Interactive comment on “Imaging tropical peatlands in Indonesia using ground penetrating radar (GPR) and electrical resistivity imaging (ERI): implications for carbon stock estimates and peat soil characterization” by X. Comas et al.

Received and published: 17 April 2015

Fig. 2.

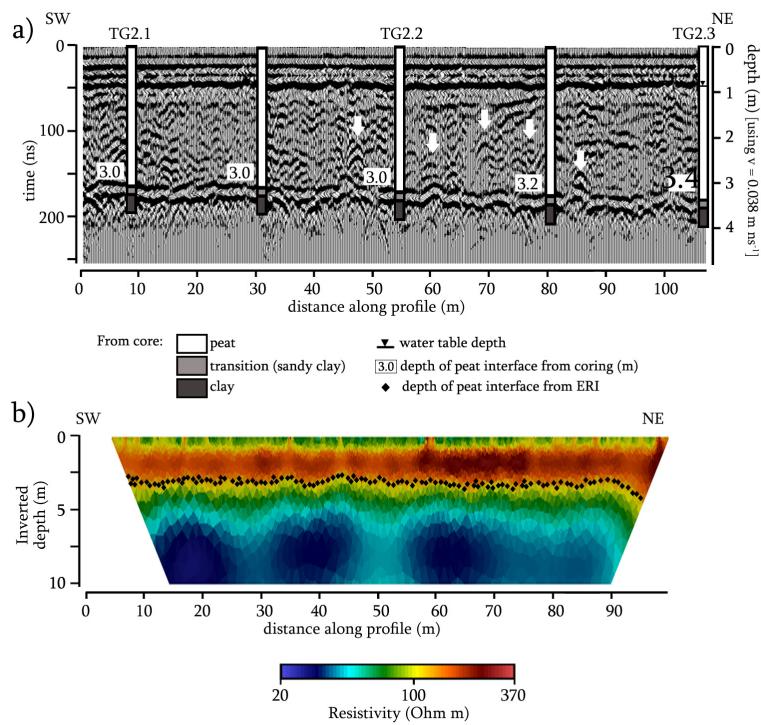
- 7. Figure 2: What is "woody layers"? In order to avoid confusion, the term "woody layer" in Figure 2 has now been replaced with "woody area" as explained in the text (section 4.1).

-8. Figure 2 and 5, 6: Water table elevation is water table depth "Water table elevation" has been replaced with "water table depth" in all figures.

Fig. 4.

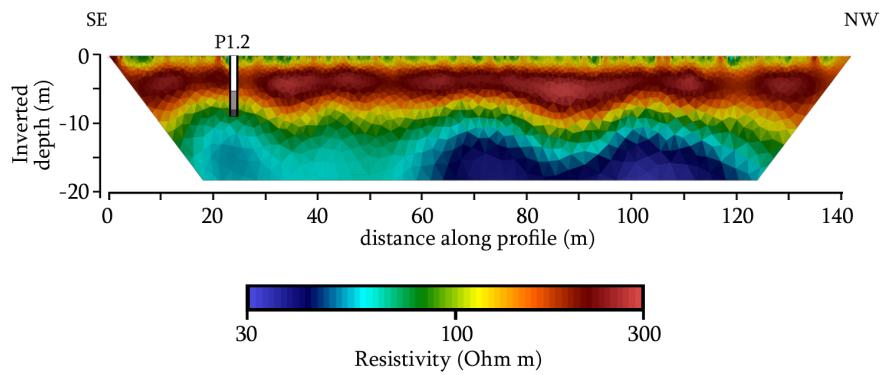
- 1. In Figure 4 (a), could you explain why you use 200 MHz instead of 100 MHz for GPR analysis? Most of the profiles shown in this paper were collected using the entire array of antennas available (i.e. 50, 100 and 200 MHz). The 50 MHz antennas however malfunctioned during the end of the campaign and therefore were unfortunately not available when investigating "deep peat" sites. For brevity purposes, only one frequency per profile is shown. Since Figure 4 corresponds to a very shallow site, we chose to display the frequency that provides best vertical resolution for shallow depths. The 200 MHz antenna has the lowest depth of penetration while providing the best vertical resolution (plus the smallest ground coupling effect) and for that reason is chosen here since we are targeting a minimum thickness of the peat column of only a few cm.
